GROUND WATER QUALITY DISCHARGE PERMIT UGW450005

**STATEMENT OF BASIS**

Low-Level and 11e.(2) Radioactive Waste Disposal Facility

February 4, 2014

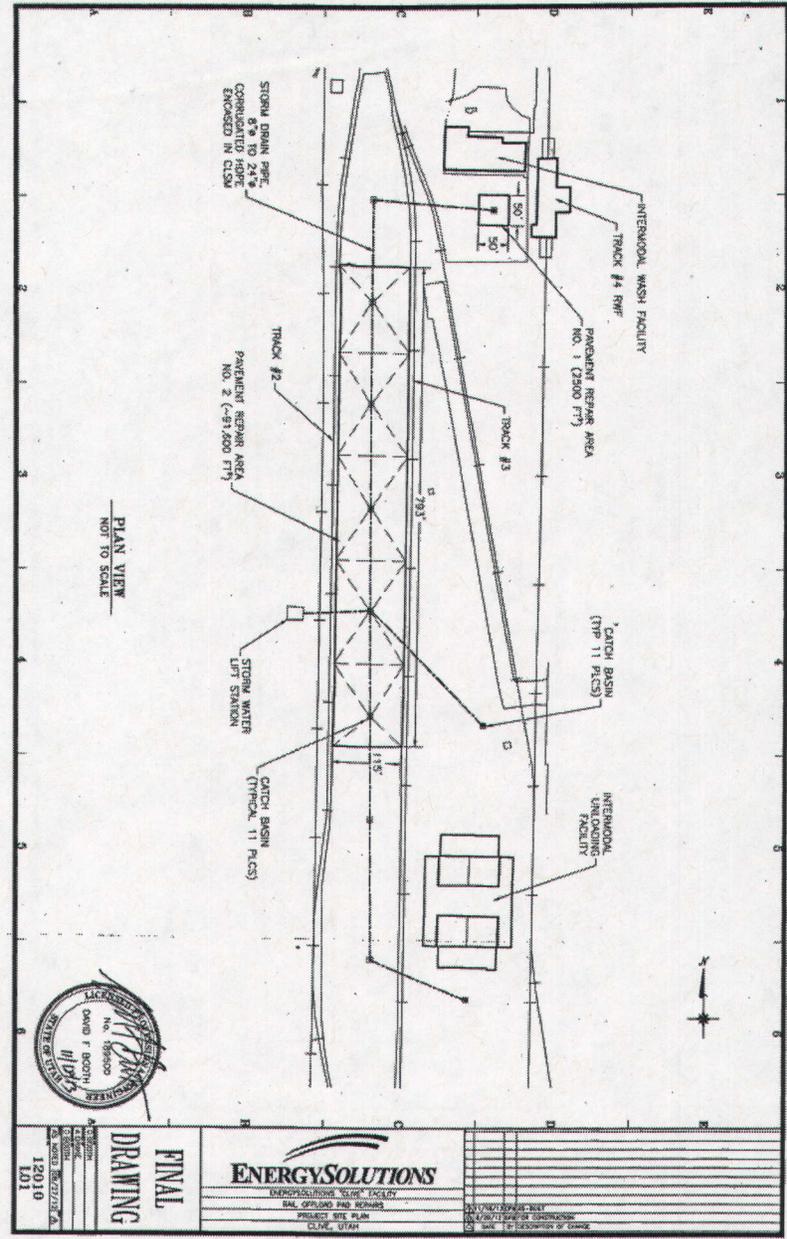
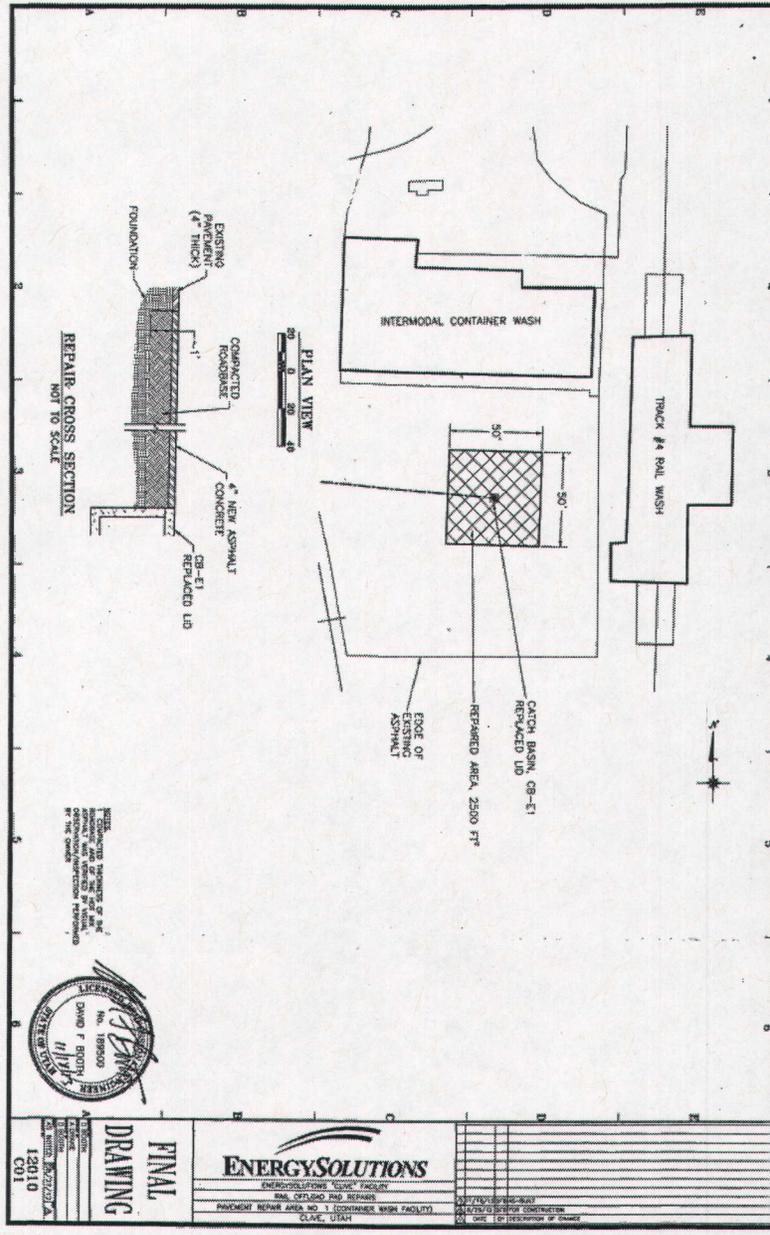
As noted in our request letters, this construction project triggers revision to Table 5 of the Permit. Specifically, the following drawing versions and dates now apply:

1. 06007-C1, Rev. 6, 7/23/12
2. 06007-C2, Rev. 6, 7/23/12
3. 06007-V1, Rev. 4, 7/23/12

No changes to these drawings are needed as a result of the construction project. Please update Table 5 with the next Permit modification.

Figure 2 Damaged stormwater collection system catch basin between tracks 2 and 3

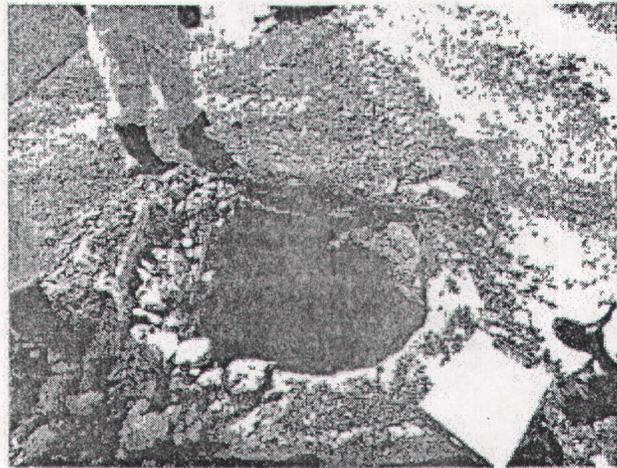
The DRCs, Charles Bishop and David Rupp, made a site visit to the EnergySolutions' Clive facility, to better understand the August 9, 2012 request and to look at the stormwater drainage system on August 23, 2012, meeting with EnergySolutions' operational and engineering staff. The stormwater collection system is part of the East Side Drainage Piping System, where stormwater is collected by catch basins located south of the intermodal container wash building, north and south of the intermodal unloading facilities, and the rail car unloading area between tracks 2 and 3. Stormwater in the system is routed to the stormwater lift sump, and collected water is pumped from the sump to the 1997 pond. The DRC staff observed that some of the catch basins located between tracks 2 and 3 have been damaged by intermodal unloading cranes and other heavy equipment driving over the catch basins. Figure 2 shows one of the damaged catch basins. EnergySolutions plans on replacing these damaged catch basins with more indestructible catch basins. The asphalt surface between tracks 2 and 3 had also been pretty much destroyed by the intermodal unloading cranes and other heavy equipment driving over it. As part of the repair of the stormwater drainage system, EnergySolutions has excavated and removed the

asphalt surface between track 2 and 3 and will replace it with a more durable asphalt surface. Figure 3 shows the excavated surface with a geomembrane placed down, before asphalt is replaced.
